Inspection of Automatic Sprinkler System

EW1 TI Automotive East London
Industrial Development Zone

UNC8802

09.05.2024 08:00 SAST

Photo 1

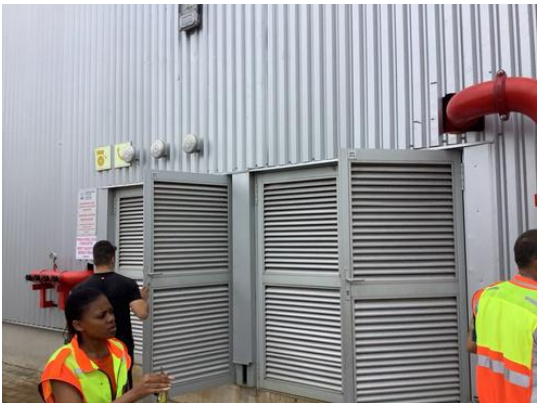
Clear access to the hand fire appliances must be maintained at all times.

Photo 3

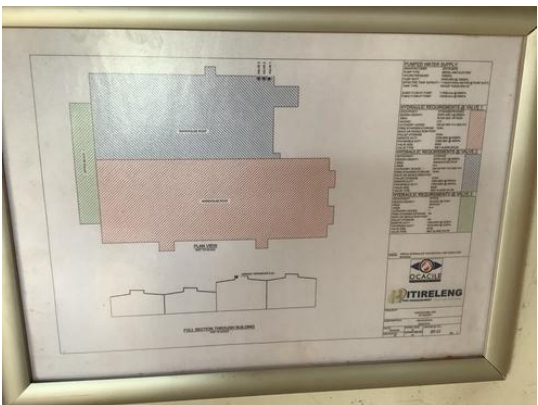
7. Installation Control Valve(s)	
7.1 Sprinkler control valves accessible	Yes
Valve Cabinet	
Valve Cabinet 1	
Location:	
Left side. West wall	
<div>   </div> <div> <div>Photo 2</div> <div>Photo 3</div> </div>	
Number of Alarm Valves Installed	1 x 150 mm, 2 x 200 mm
7.2 Sprinkler Valve Location Plate Installed	Yes
7.3 Fire Brigade Booster Pressure Limitation Plate	Yes
7.4 Block Plan Installed	Yes
7.4.1 Is the block plan labelled in accordance with the areas fed by the sprinkler control valve assemblies	Yes
7.4.2 Are the correct installation details recorded on the block plan	Yes
<div>   </div> <div> <div>Photo 4</div> <div>Photo 5</div> </div>	
7.5 Sprinkler Valve Instruction Chart	Yes
7.6 Is a sprinkler spares box present	Yes
7.6.1 Was the spares box contents accessible	Yes
7.6.2 Are the spares quantities correct	Yes
7.7 By Pass Arrangement Installed	Yes

Photo 29

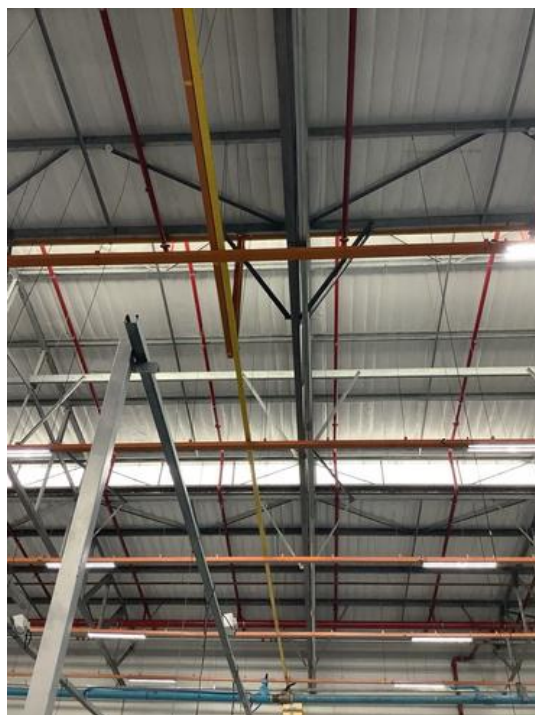
Sprinklers exceed 600 mm from isotherm panel wall
